APPLICATION NO.	FILING DATE	FIRST NAMED INVENTOR	ATTORNEY DOCKET NO.	CONFIRMATION NO.
09/552,713	04/19/2000	Koukichi Masumoto	3064NG/48834	3146
7590	12/16/2005		EXAMINER	
Crowell & Moring LLP Intellectual Property Group P O Box 14300 Washington, DC 20044-4300			TUGBANG, ANTHONY D	
			ART UNIT	PAPER NUMBER
			3729

Office Action Summary	Application No.	Applicant(s)	
	09/552,713	MASUMOTO, KOUKICHI	
	Examiner	Art Unit	
	A. Dexter Tugbang	3729

DETAILED ACTION

Attachment A

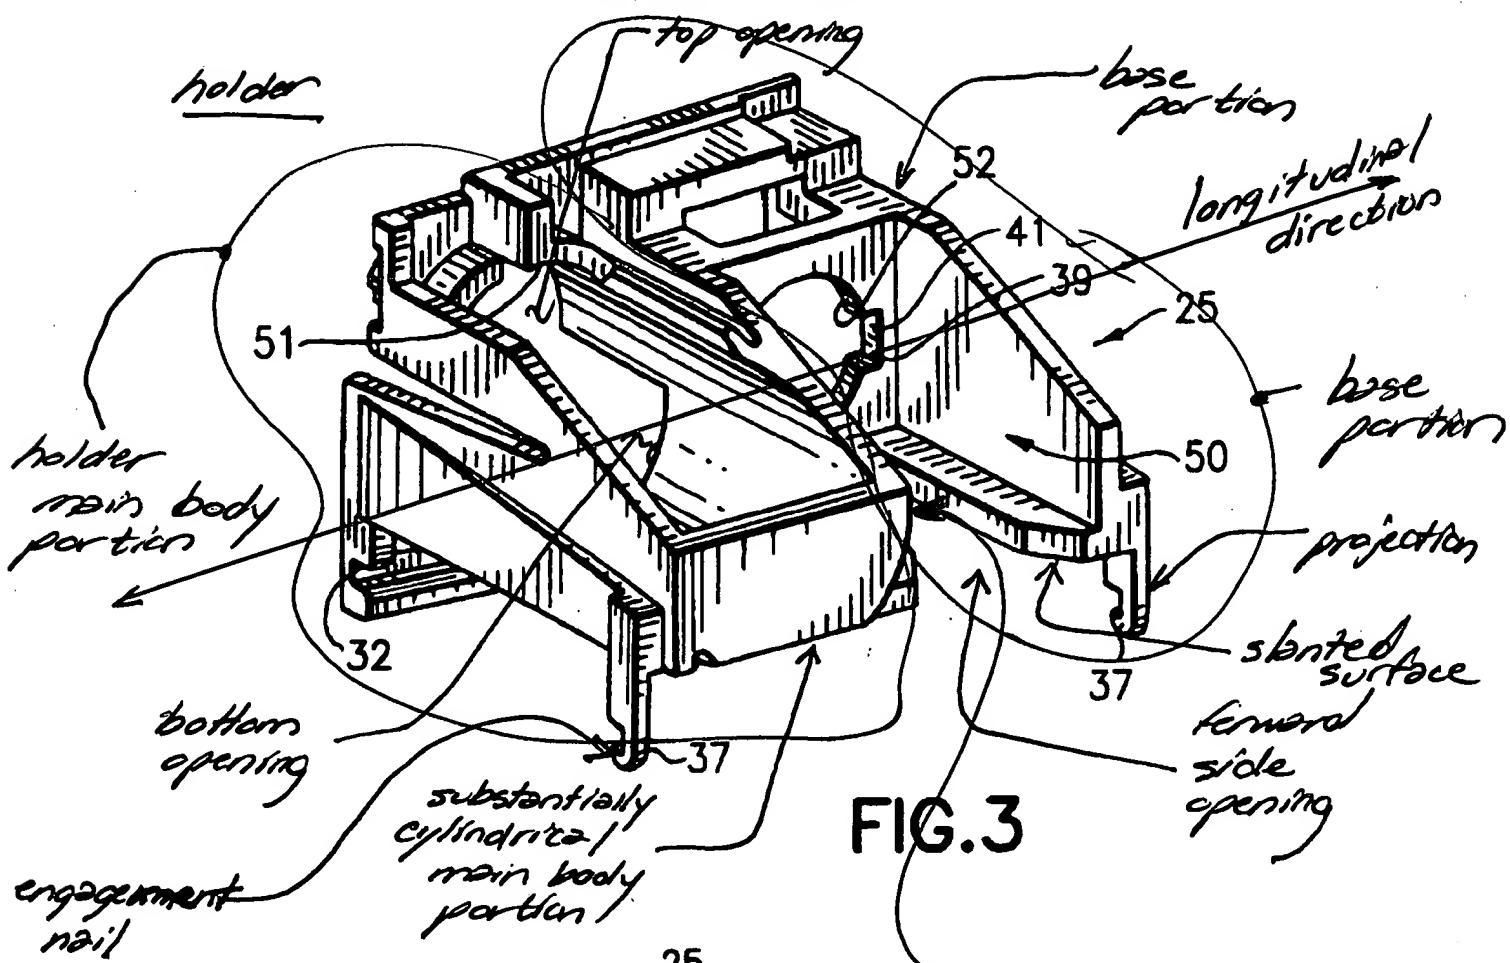
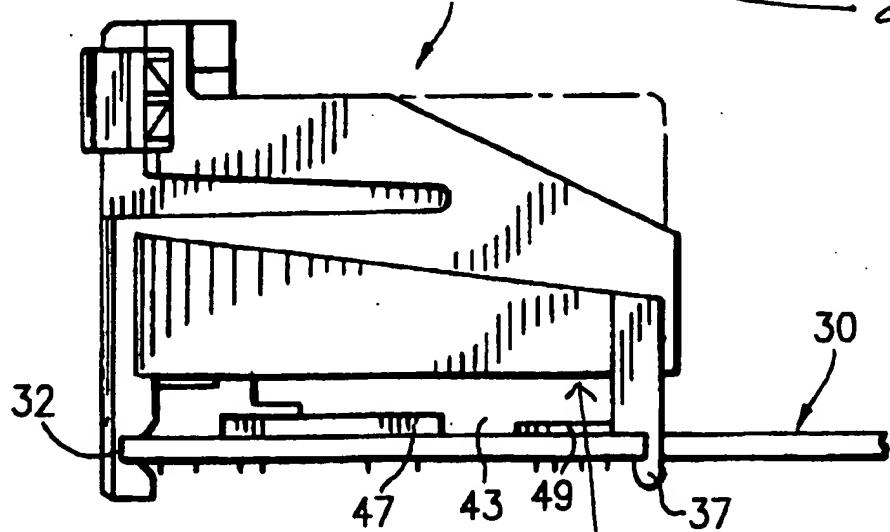
Byrd discloses a fixing holder comprising a holder that is engaged with a printed circuit board. The examiner has provided Attachment A herein to show all of the structural elements of the claims, i.e. “holder main body portion” with top and bottom openings, “base portion”, “projection”, etc. The claimed “slanted surface” labeled in Attachment A is capable of contacting an upper surface of the printed circuit board by turning the fixing holder over.

Regarding Claim(s) 8 and the detailed recitation at lines 5-8, Byrd shows in Figure 5 an electrical component (battery 27a) that is arranged in an area of the top opening and wire-shaped leg portions (wires not labeled) protruding from the bottom opening. Moreover, the Attachment A has been further labeled to show the claimed “side surface” of the holder main body portion, which is on a side and includes a “projection” (37) that directly engages the printed circuit board (see Fig. 4).

The examiner has again provided Attachment A to illustrate his point in that the claims only require one direction, i.e. longitudinal direction, and that while the examiner agrees with the applicant(s) that the base portion extends from the holder main body portion in a lateral direction, or in a laterally adjacent direction, this lateral direction can be read as the "longitudinal direction". Therefore, Byrd fully satisfies these limitations directed to the "longitudinal direction".
